# Evaluation of the Tokyo Electric Power Company's Report Regarding Tank Area In-Dike Rainwater Leakage at the Fukushima Daiichi Nuclear Power Station

Nuclear Regulation Authority (NRA)

March 30, 2016

**Figure 2. Side-ditch drainage water radiation monitor readings and seawater monitoring results**

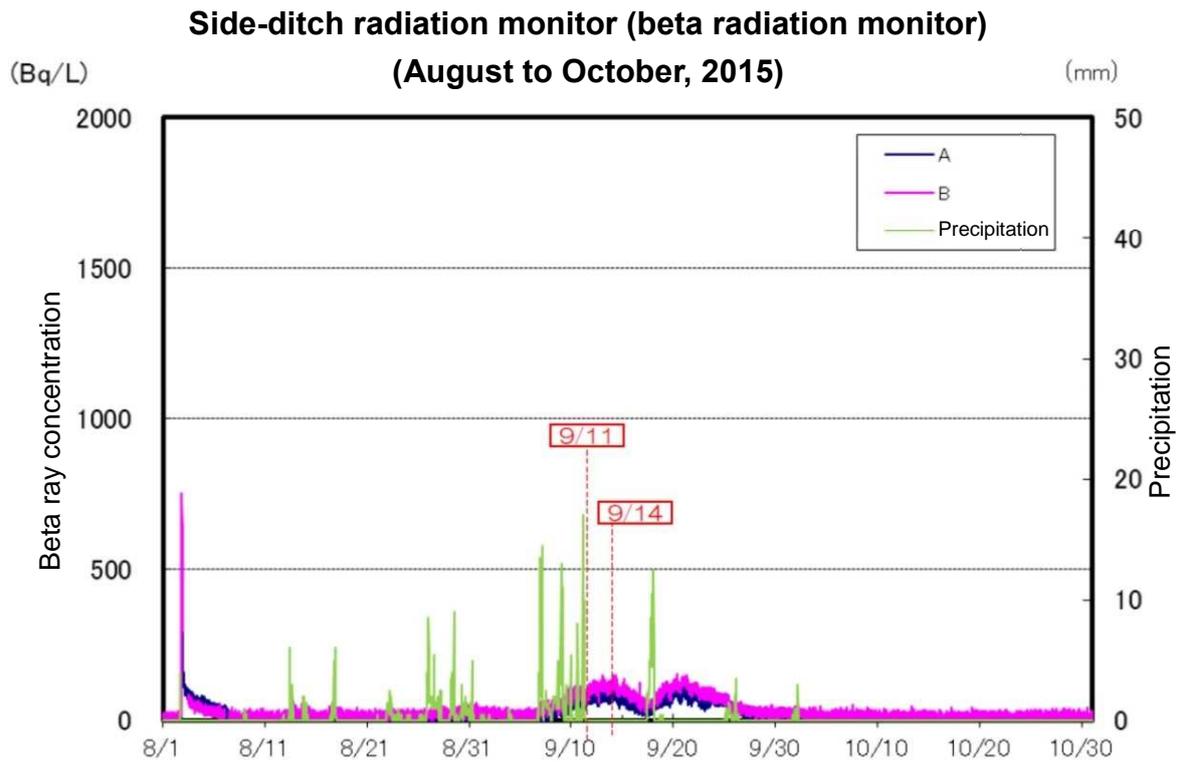
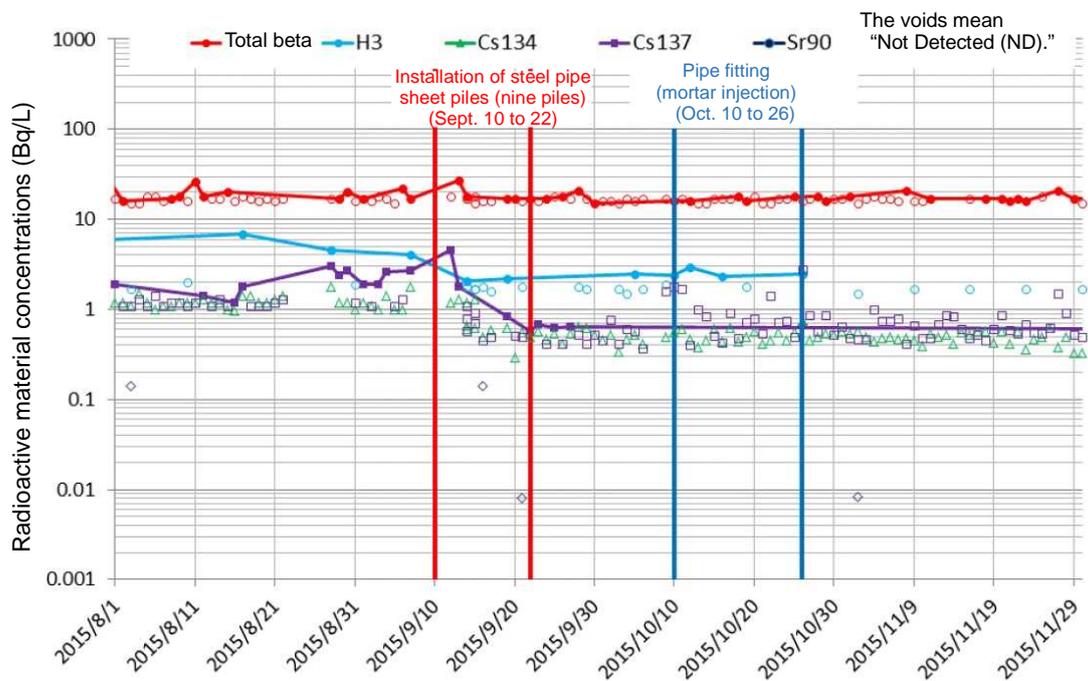
As a result of analyzing the readings from a side-ditch drainage radiation monitor installed in drainage channel C, which is downstream of the H4 north and H6 tank areas, as well as radioactivity at the port entrance, no significant total beta nuclide concentration difference before and after the leakage indicating leaked water outflow into the outside of the port was observed (see Figure 2). Therefore, no seawater contamination is considered to have occurred that posed health and environment concerns.

**Figure A. Situation of leakage at the H4 north tank area (excerpt from the TEPCO report)**

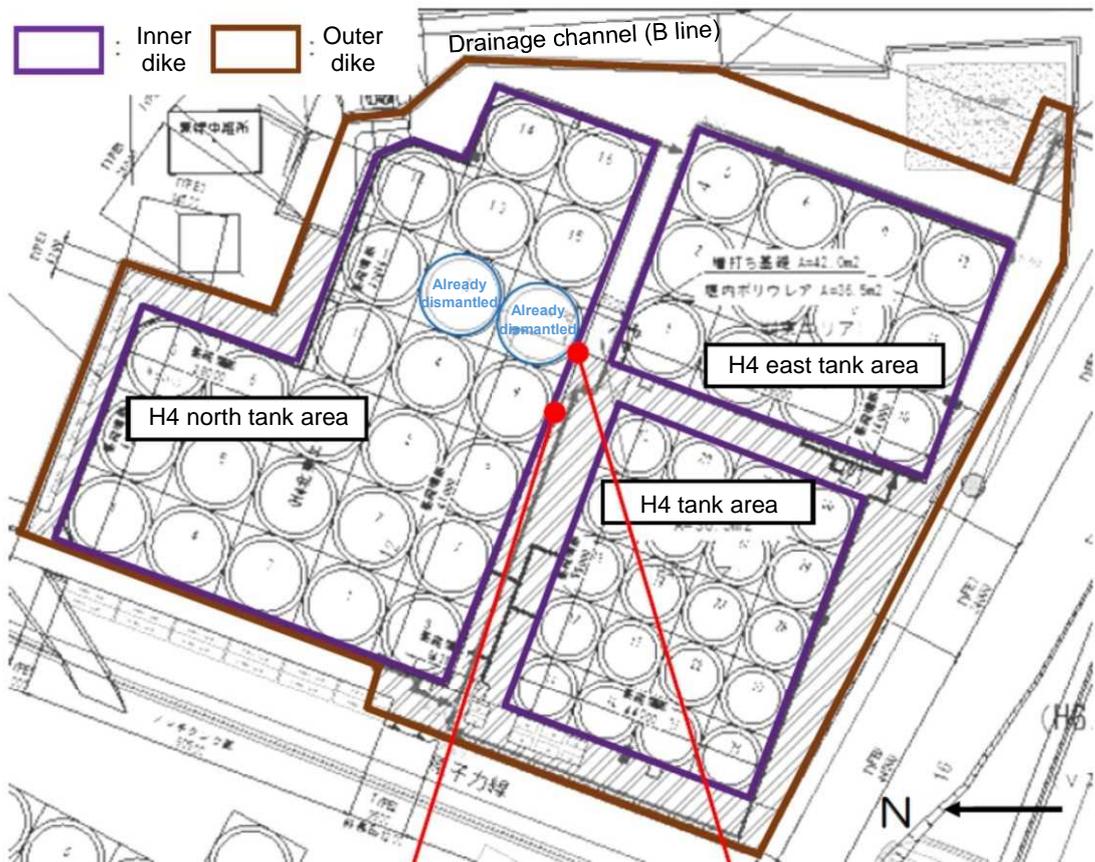
<Leakage found on Sept. 11>  
 ① Pencil-size leakage occurred from the bolt hole.  
 \* No damage or dent was found.

<Leakage found on Sept. 12>  
 ② Leakage at a rate of one drop per 10 seconds from the bolt section  
 \* No damage or dent was found.

- ① A measure applied to the elevated inner dike's joint and mount bolts  
Polyurea will be applied to the inner dike boundary from outside, which will enhance water-stopping effect and reduce the risk of leakage.

**Figure B. Situation of H6 tank area leakage  
(excerpt from the TEPCO report)**

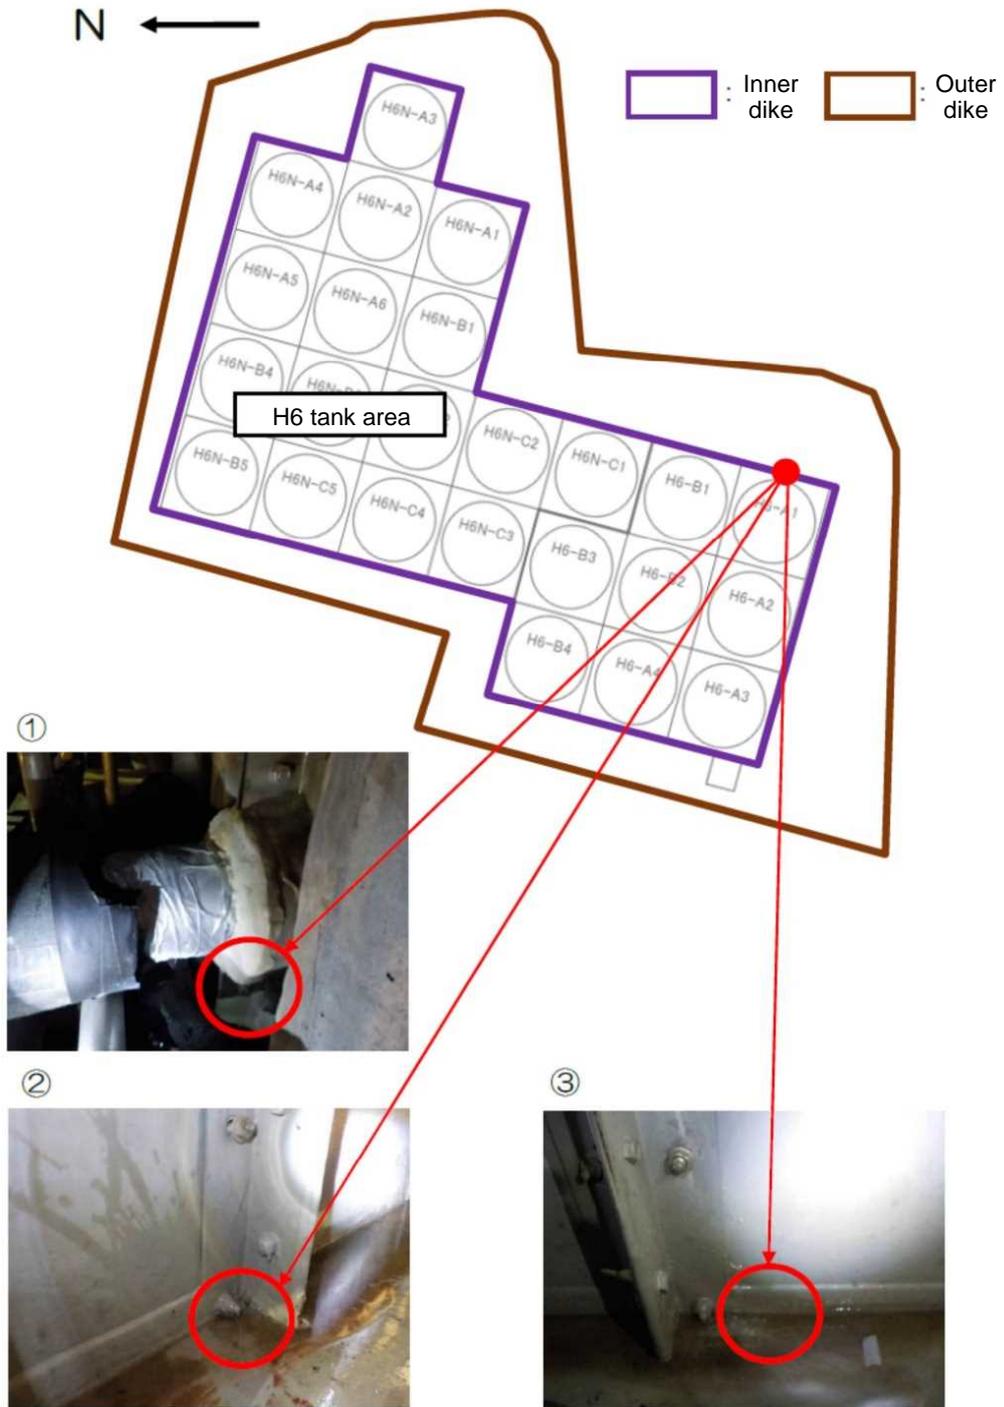
①: Leakage from a pipe penetration of steel dike

② and ③: Leakage from these two joints

- ② Measures applied to the inner dike's pipe penetrations  
Pipe penetrations will be provided with water-stopping means both from inside and outside and localized water-filling tests will be carried out, which will reduce the risk of leakage.
